Power Genius XL™ Release Notes – Version 3.7.28

January 3, 2023

Power Genius XL v3.7.28 is a feature release for use with all Power Genius XL (PGXL™) amplifiers.

Band Data Source Selection, Manual and Automatic

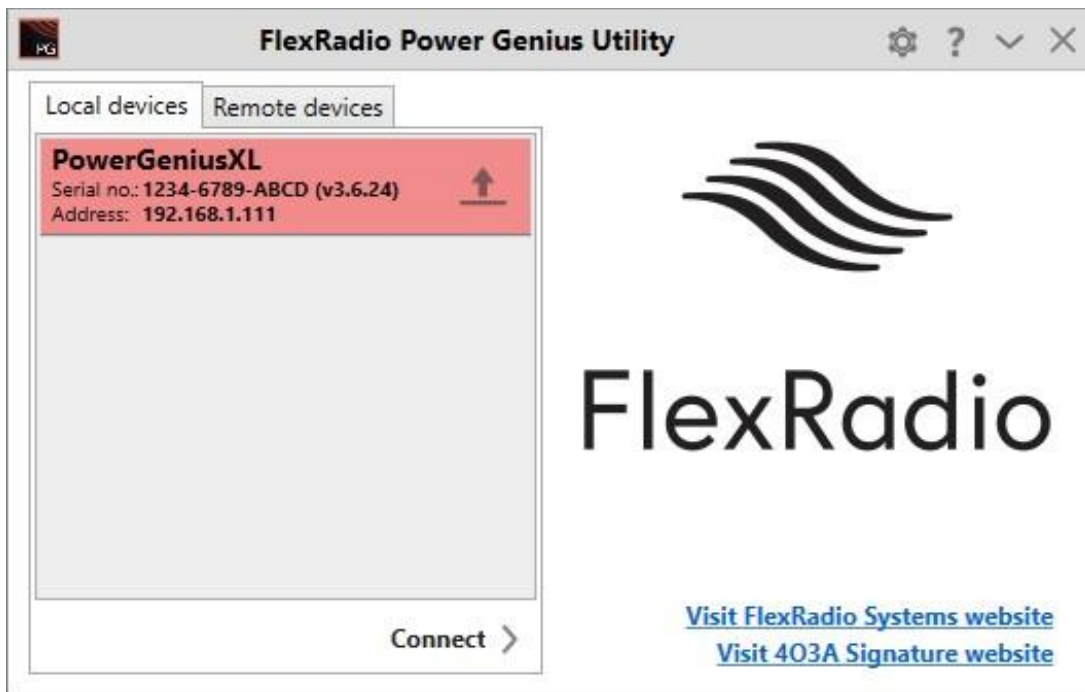
Band data sources can be selected manually or automatically. In manual mode, the default, the operator selects the source for band data (FLEX, CAT, CI-V, BCD, PIN, RF SENSE, or MANUAL). In automatic mode, the amplifier chooses the input based on which is active.

The amplifier's source of band data information is now directly controlled by the operator. When no band data source has been configured, the amplifier will operate as before, it will select any source that offers information. When a band data source has been configured, the amplifier will use that source exclusively until the source is changed by the operator. This can be done via the Windows Utility program or the front panel touchscreen. Select the band data source by right-clicking on the Band Information box in the front panel presented by the Utility program, or by touching the band information box on the front panel.
